Re: Technical Deficiency Letter (TDL)
Quaker Valley School District
NPDES Permit Application No. PAD020098
Leet Township, Leetsdale & Edgeworth Boroughs, Allegheny County

Technical Deficiencies

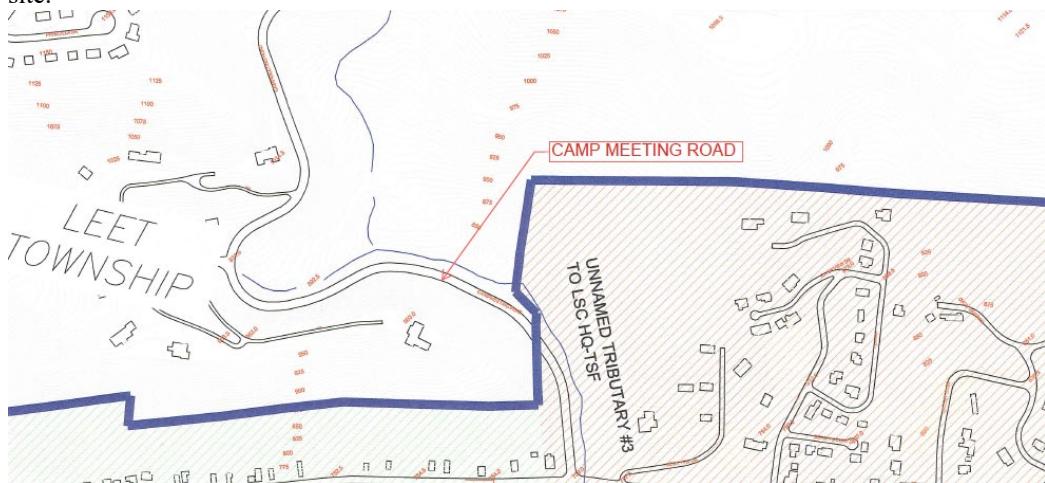
115. §102.4(b)(5)(i): Show existing buildings adjacent to the site on the drawings.

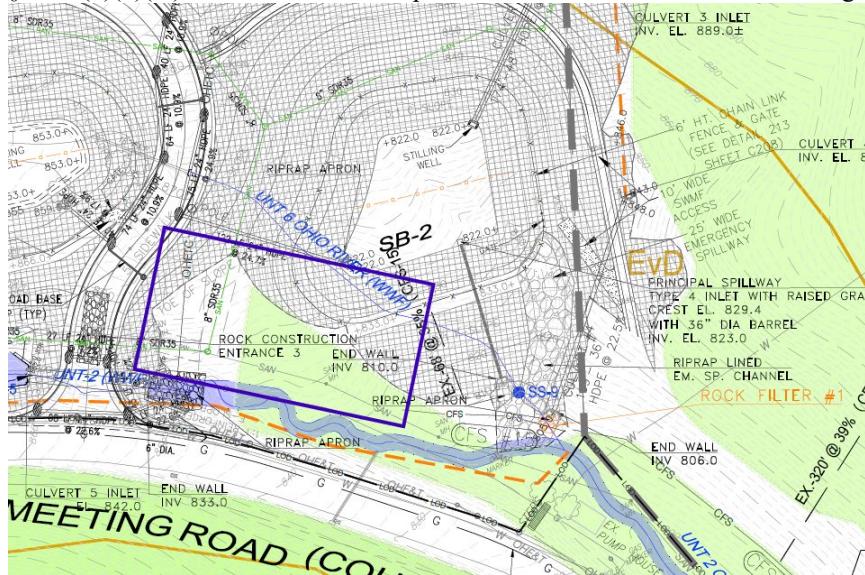
147. §102.4(b)(5)(vii): Phase 1: Clarify if all existing building demolition will occur concurrently, or if these will be done in a certain order.

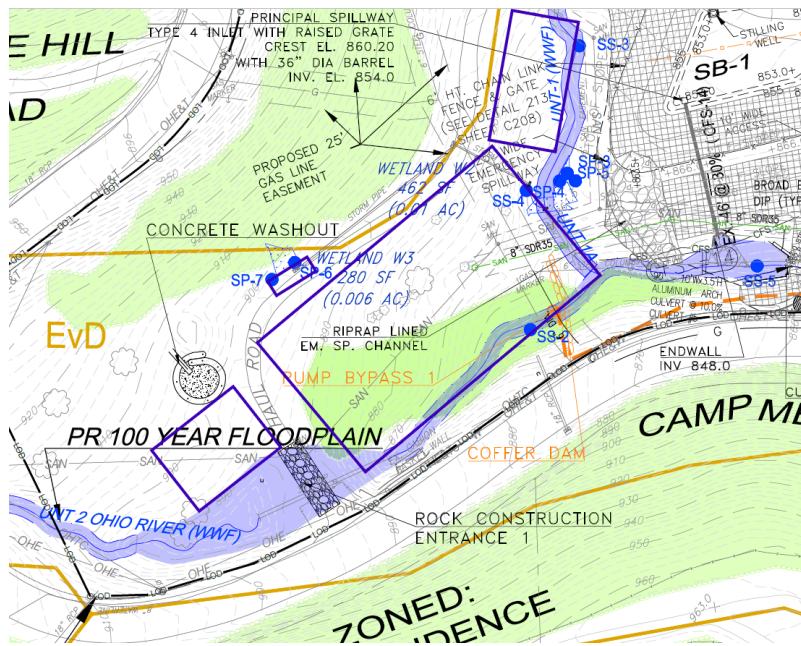
152. §102.4(b)(5)(ix): Phase 1: Additional perimeter CFS is needed below Basin 2 grading in this area:

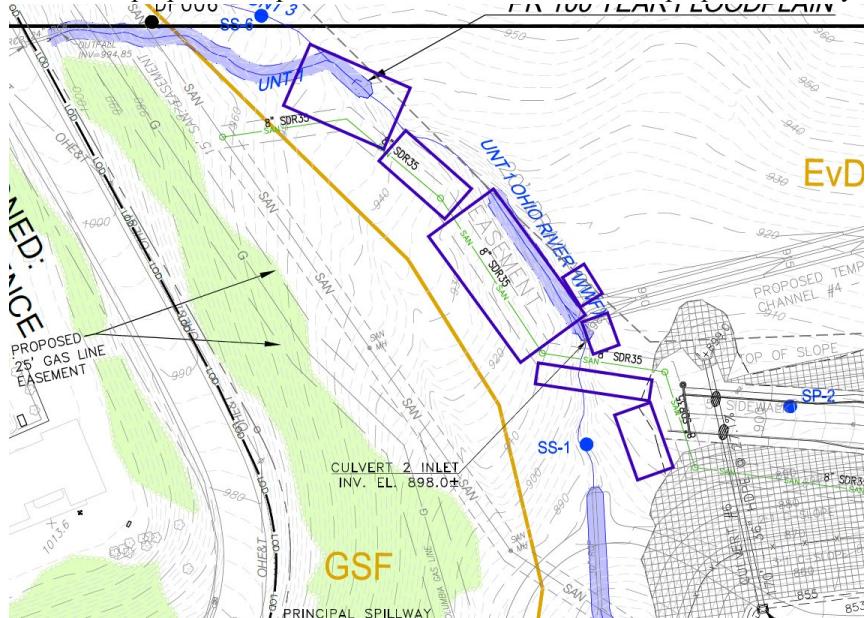
154. §102.4(b)(5)(ix): Phase 1: Provide E&S controls for utility work associated with relocation of the gas and sanitary lines. Several areas are not in an area that would flow to an already proposed section of CFS.
